AIRWORTHINESS DIRECTIVE

Cessna 205 (210-5) Series Aeroplanes

**AD/CESSNA 205/21
Amdt 2**

Forward Door Post Bulkhead

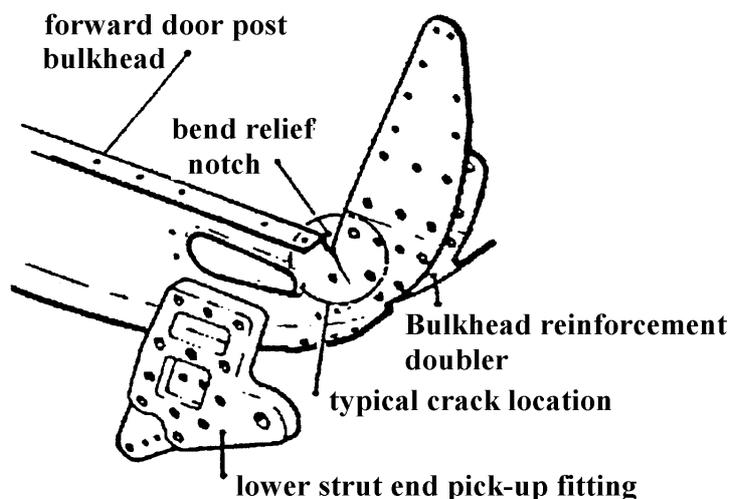
1. Visually inspect for cracks at the inside edge of the left hand and right hand bend relief notches of the forward door post bulkhead.
2. Visually inspect for loose or working fasteners securing the lower strut end pick-up fitting to the forward door post bulkhead. The inspection areas and typical crack location are shown in the diagram below.

Note 1: Inspection in accordance with Requirement 1 will initially require removal of certain floor panels. Incorporation of inspection holes in accordance with an approved modification will allow inspection of the relief notch without requiring removal of the floor panels.

Note 2: Inspection in accordance with Requirement 2 may be accomplished from outside the aircraft via the hole exposed by removing the lower wing strut fairing.
